Remarks

Drawings and Specification - Numeral Correspondence

*Fig. 1*

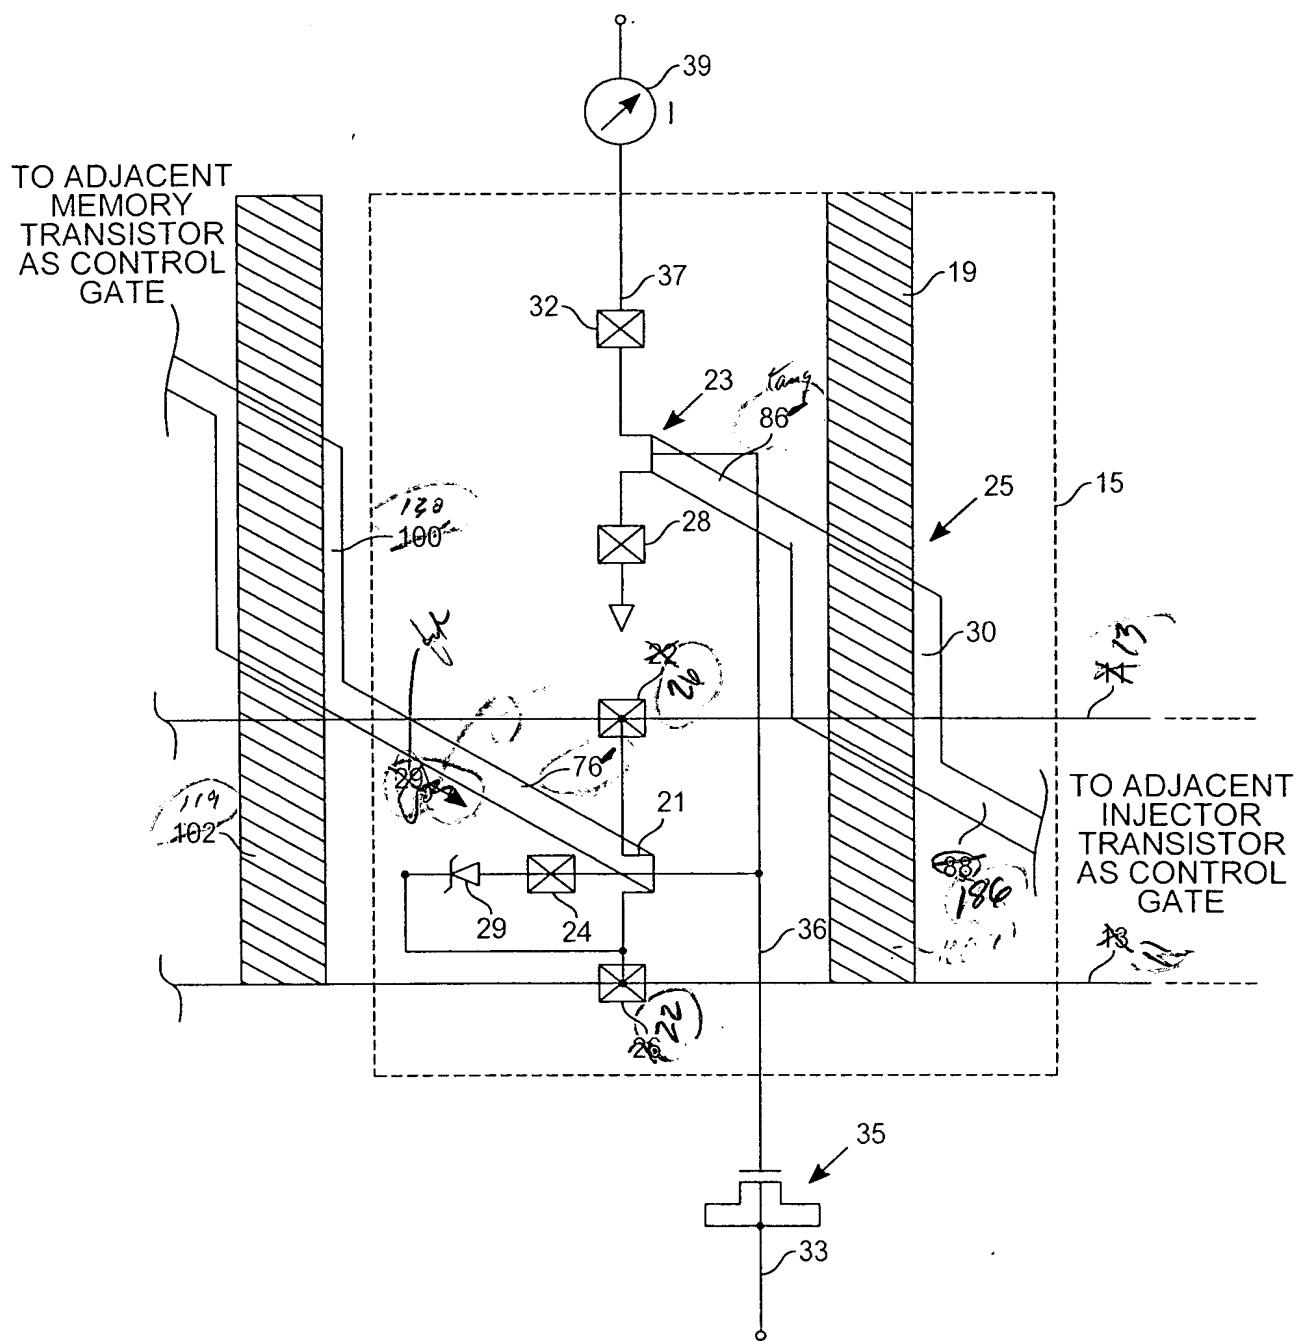
Reference numeral "16" in Fig. 1 has been removed.

Fig. 2

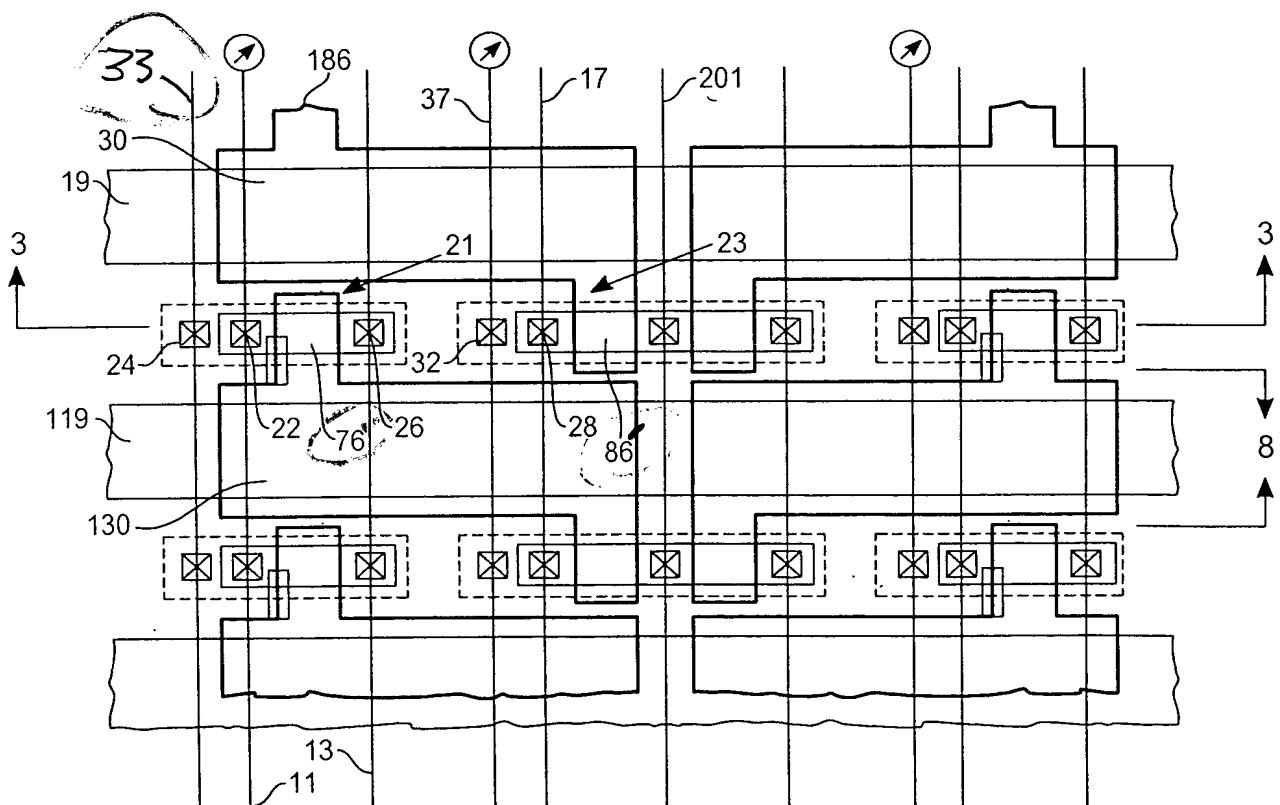
Reference character 28 is a cathode of diode 29 as noted by the Examiner and so page 9, line 8 has been amended to delete "28" as a contact and arrow 29 in Fig. 2 has been deleted.

In relation to Fig. 2, pages 6 and 7 of the specification (pages 4-5 herein) tang 76 has been changed to tang 76'. Plate "100" has been changed to - - 130 - - and word line "102" has been changed to - - 119 - - for consistency. Other tang membering has been changed or clarified in the same

paragraph so that the 3-dimensional tangs of Fig. 2 will relate to the 2-dimensional transistor elements shown in Figs. 3 and 4. The Examiner on page 5 of the Office letter points out certain informalities, namely that reference numeral "86" is described in different ways. To correct this, Applicant has amended the specification to call out reference numeral 86 as a "control poly gate" since it is both a control gate and a poly gate. In three dimensions, the gate extends from a poly plate as a tang, but the reference numeral has been changed to 86' when it appears as a tang, as mentioned above. This change has been made on the drawings as well as the specification. The same is true for tang 76'.

In Fig. 2, the orientation of the diode has been reversed by reversing contacts 22 and 26 and associated lines 11 and 13.

On page 6 of the Office letter, the Examiner is correct in assuming that transistor "31" should be - - 21 - -. Reference numeral "90" should be - - 76' - - in reference to a tang in Fig. 2. Both the drawing of Fig. 2 and the specification have been amended.

*Fig. 4*

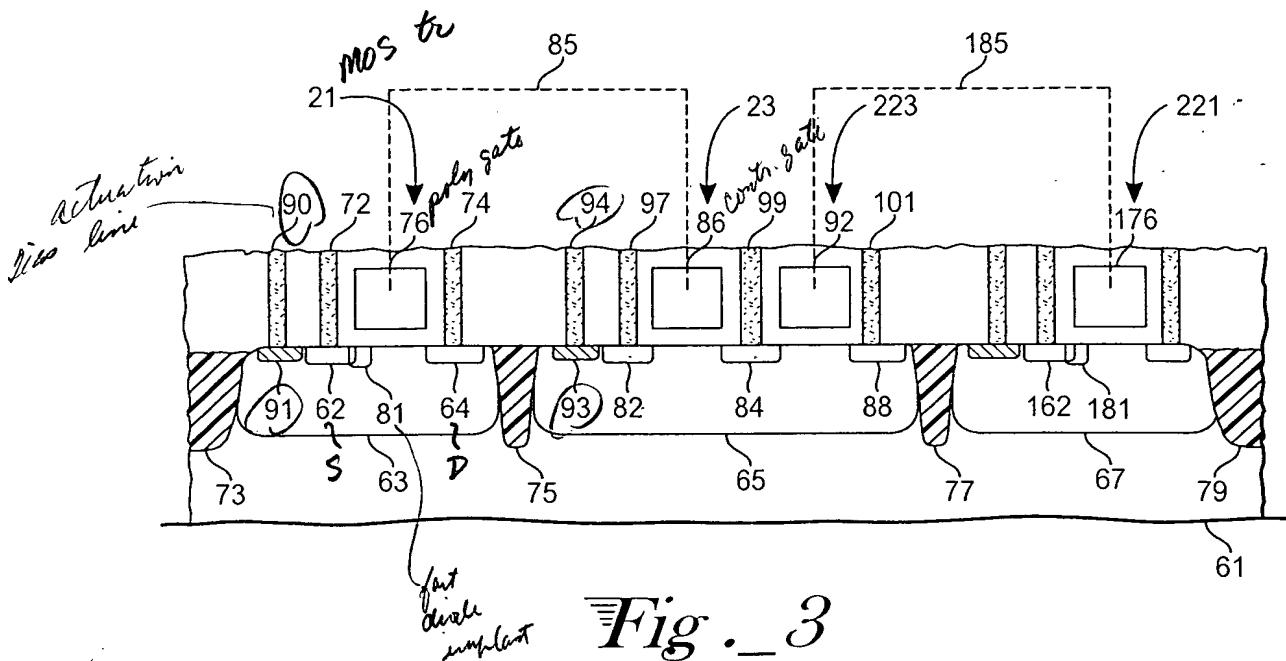
Claim 21 has been amended to recite that a single word line can select two transistors for simultaneous write and erase (using the tangs discussed above). For example, word line 119 in Fig. 4 supports this. On the other hand, Wong et al. require use of two different word lines for simultaneous write and erase. There is no anticipation because Wong et al. does not have a single word line for simultaneous write and erase in different cells.
